Reference: 701 D Street Park Air Quality Analysis Addendum (RECON Number 8819)

DRAFT PARK MASTER PLAN - D STREET @ WOODLAWN AVENUE

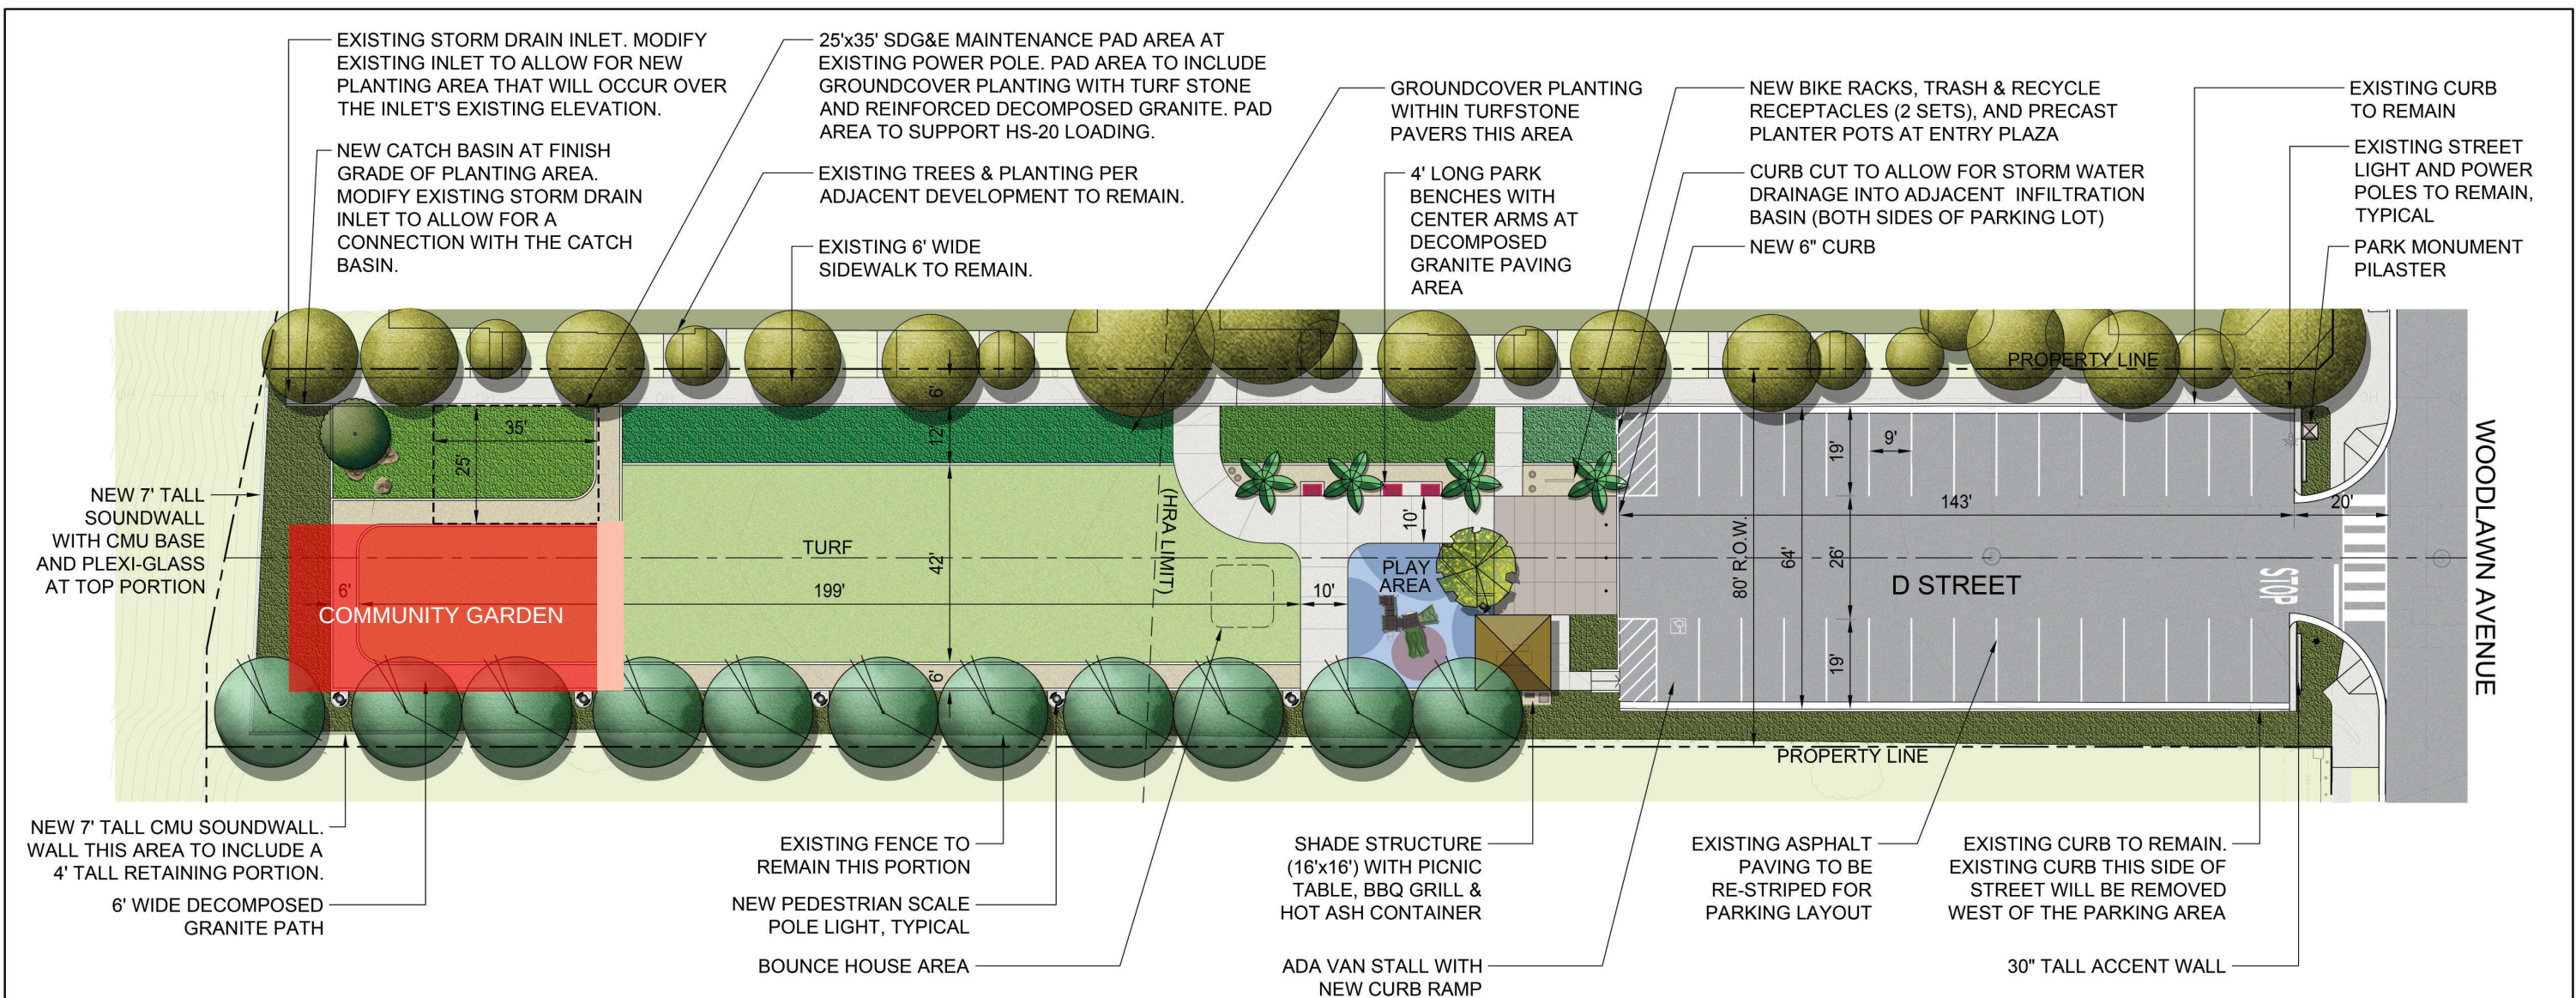
The revised project plans would locate a community garden in the western end of the proposed park near Interstate 5. Therefore, the City has requested additional information on the potential cancer risk from diesel-exhaust particulate matter (DPM) due to the closer proximity of people using the garden to Interstate 5 than previously assessed. Additionally, the City has requested information on the potential for additional cancer risks from ingestion of DPM due to crops grown within the community garden, see Attachment 1.

Cancer risk associated with inhalation pathways was assessed in the project Air Quality Analysis. The project would result in an incremental cancer risk of 4.2 in one million. This assumed an average exposure of 0.04 microgram per cubic meter ($\mu\text{g}/\text{m}^3$). The proposed community garden is located between 20 and 90 feet from the western property line. Based on Figure 4 of the project Air Quality Analysis, this would result in exposures to ground-level concentrations of DPM between 0.06 and 0.05 $\mu\text{g}/\text{m}^3$ and result in 30-year cancer risks between 5.2 and 6.3 in one million. As the excess cancer risk would remain below 10 in one million, the findings of the project Air Quality Analysis would not change.

A small subset of toxic substances are subject to deposition onto soil, plants, and water bodies. These substances need to be evaluated by the appropriate non-inhalation pathways, as well as by the inhalation pathway. Potential non-inhalation pathways include: soil ingestion; dermal contact; meat, milk and egg ingestion; fish ingestion; exposed vegetable ingestion; leafy vegetable ingestion; protected vegetable ingestion; root vegetable ingestion; water ingestion; or breast milk ingestion. Substances subject to deposition onto soil, plants, and water bodies are referred to as multi-pathway substances. Such substances include semi-volatile organic chemicals and heavy metals. According to the 2015 *Air Toxics Hot Spots Program Guidance Manual for the Preparation of Risk Assessments*, issued by the Office of Environmental Health Hazard Assessment, DPM is not considered a multi-pathway substance. Therefore, cancer risk associated with DPM is limited to inhalation pathways and no additional cancer risk would be associated with ingestion of DPM.

In conclusion, locating a community garden near Interstate 5 would not result in significant DPM cancer risks. No change in findings of the Air Quality Analysis would occur.
